Proposal for amendments to UN Regulation No. 130 – Lane Departure Warning System (LDWS)

This document proposes an amendment to the original text of United Nations Regulation No. 130 – Lane Departure Warning Systems (LDWS). This proposal intends to facilitate effective functioning of the LDWS fitted to Australian supplied vehicles of category M2, M3, N2 and N3 primarily used under highway conditions.

"Annex 3

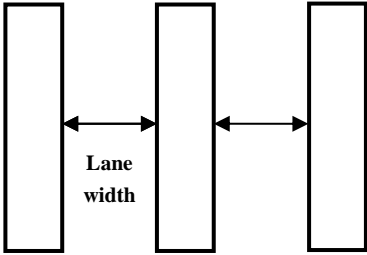
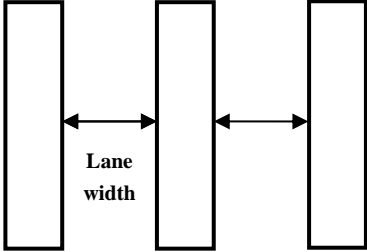
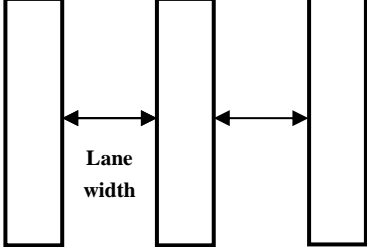
Annex 3., amend to read:

1. The expert from Australia proposes to include amendments to Annex 3 of UN Regulation No. 130 to account for Australian-specific lane marking identification ensuring vehicles will be designed for operation in the Australian market.

4. The Lane Departure Warning System should be able to:
 - Detect edge line or outline markings of 15 or 20 cm thickness;
 - Detect variations in longitudinal gaps between lane markings ranging from a minimum of 3 m to a maximum of 9 m; and

- Detect unique Australian barrier lines separated by a 10 cm lateral gap between the 10 cm thick dividing lines.
5. The Australian Government has consulted nationally on UN Regulation No. 130 in early 2022 and is seeking to propose a mandate on November 2025 for new types (new models) and November 2027 for all types (all vehicles) for motor vehicles of categories M₂, M₃, N₂ and N₃. This is subject to the relevant Minister's signature on the national road vehicle standard (also known as an Australian Design Rule).

Pattern			Country	Width		
Left edge lane marking	Centre line	Right edge lane marking		Left edge lane marking	Centre line	Right edge lane marking
			Definition of lane width for the purpose of this Regulation			
			UNITED KINGDOM Single Carriageway (speed limit >40 mph)	10 or 15 or 20 cm	10 or 15 cm	10 or 15 or 20 cm
<p>Undivided road with one lane each way</p>			AUSTRALIA Two-lane, two-way road	15 or 20 cm	10 cm	15 or 20 cm
<p>Central dividing line on an undivided road with more than one lane each way</p>			AUSTRALIA Multi-lane undivided road	15 or 20 cm	10 cm	15 or 20 cm

Pattern			Country	Width		
Left edge lane marking	Centre line	Right edge lane marking		Left edge lane marking	Centre line	Right edge lane marking
			Definition of lane width for the purpose of this Regulation			
			AUSTRALIA Two-lane, two-way road with lane changing allowed from one direction only	15 or 20 cm	10 cm 10 cm 10 cm	15 or 20 cm
			AUSTRALIA Two-lane, two-way road with lane changing not allowed	15 or 20 cm	10 cm 10 cm 10 cm	15 or 20 cm
			AUSTRALIA Single barrier line	15 or 20 cm	10 cm	15 or 20 cm
